Access Compliance Report

Public Rights-of-Way

Intersection ID: 5212	Main Street: BELLHAVEN_BV	Cross Street: CAMERON_SPRING_RD	Location: SW
ADA ID: 413945D70B00	Ramp Type: Perp	Initial Pass/Fail: Fail	Overall Compliance: No
Codes/Mitigation Info/Possible Solution			Severity Score: 25
			Field Measurements/Component Compliance

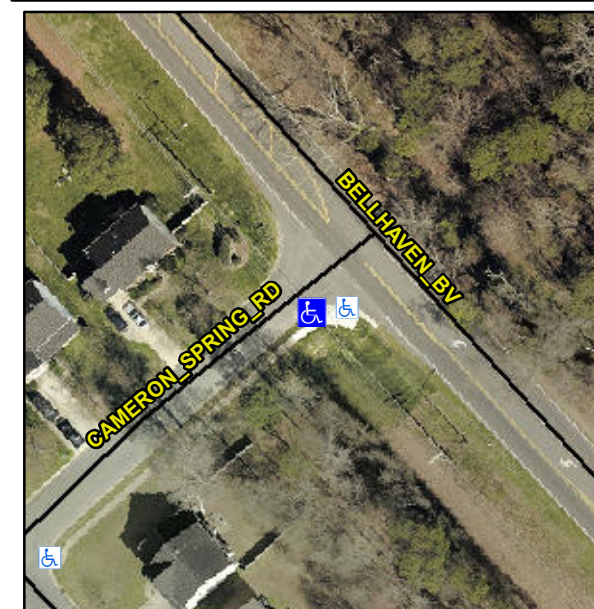
Not Found, R304.2.2, R304.5.3

Compliance	Description	Data	Compliance	Description	Data
N/A	Ramp Length (in)	48.0	No	Ramp Slope (%)	11.0
Yes	Ramp Width (in)	52.0	No	Ramp XSlope (%)	6.0
N/A	Flare Type LT	N/A	N/A	Flare Type RT	N/A
N/A	Flare Slope LT (%)	N/A	N/A	Flare Slope RT (%)	N/A
N/A	Flare Traversable LT?	N/A	N/A	Flare Traversable RT?	N/A
N/A	Landing Length (in)	N/A	N/A	DWS Provided?	N/A
N/A	Landing Width (in)	N/A	N/A	DWS Contrast?	N/A
N/A	Landing Slope (%)	N/A	N/A	DWS Length (in)	N/A
N/A	Landing X Slope (%)	N/A	N/A	DWS Full Width?	N/A
N/A	Landing Curb? (Y/N)	N/A	N/A	DWS Offset (in)	N/A
N/A	Shared Landing?	N/A			
N/A	Gutter Ponding?	N/A	N/A	Gutter Slope (%)	N/A
N/A	Gutter Lip Ht (in)	N/A	N/A	Gutter X Slope (%)	N/A
N/A	Painted X Walk1?	No	N/A	Painted X Walk2?	N/A
	X Walk 1 Direction	To NE		X Walk 2 Direction	N/A
N/A	X Walk 1 Width (in)	N/A	N/A	X Walk 2 Width (in)	N/A
	X Walk 1 Slope (%)	3.6		X Walk 2 Slope (%)	N/A
	X Walk 1 X Slope (%)	4.8		X Walk 2 X Slope (%)	N/A

Remove & Replace Entire Ramp.
